Title - Sujet Lane Repair POE Coutts	
Solicitation No. - N° de l'invitation EP922-171435/A	Amendment No. - N° modif. 002
Client Reference No. - N° de référence du client CBSA EP922-171435	Date 2016-11-03
GETS Reference No. - N° de référence de SEAG PW-\$PWU-202-10882	
File No. - N° de dossier PWU-6-39192 (202)	CCC No./N° CCC - FMS No./N° VME
Solicitation Closes - L'invitation prend fin at - à 02:00 PM on - le 2016-11-10	
Time Zone Fuseau horaire Mountain Standard Time MST	
F.O.B. - F.A.B. Plant-Usine: <input type="checkbox"/> Destination: <input checked="" type="checkbox"/> Other-Autre: <input type="checkbox"/>	
Address Enquiries to: - Adresser toutes questions à: Giguère, Mario	Buyer Id - Id de l'acheteur pwu202
Telephone No. - N° de téléphone (780) 246-0393 ()	FAX No. - N° de FAX (780) 497-3510
Destination - of Goods, Services, and Construction: Destination - des biens, services et construction:

SOLICITATION AMENDMENT 002

This solicitation amendment is raised to address the following:

DOWEL BAR ASSEMBLY

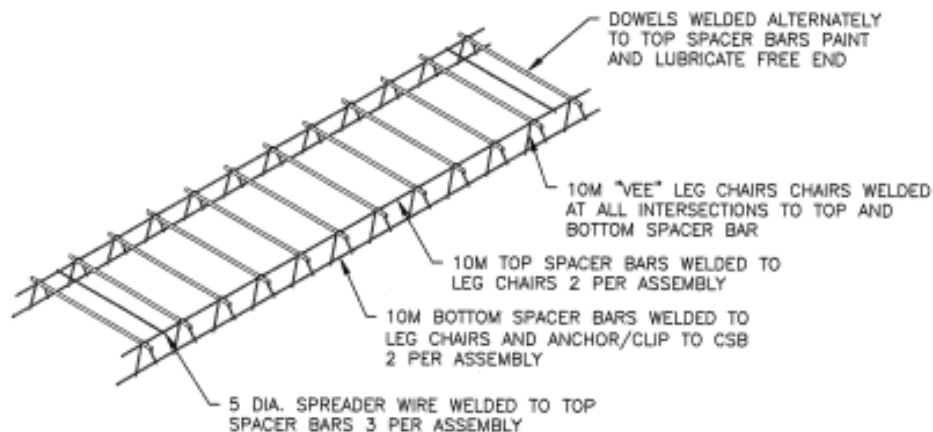
Q11: Can the consultant provide additional detail on the dowel baskets?

A11: A detail of the dowel basket will be provided as an addendum to the Buy and Sell posting.
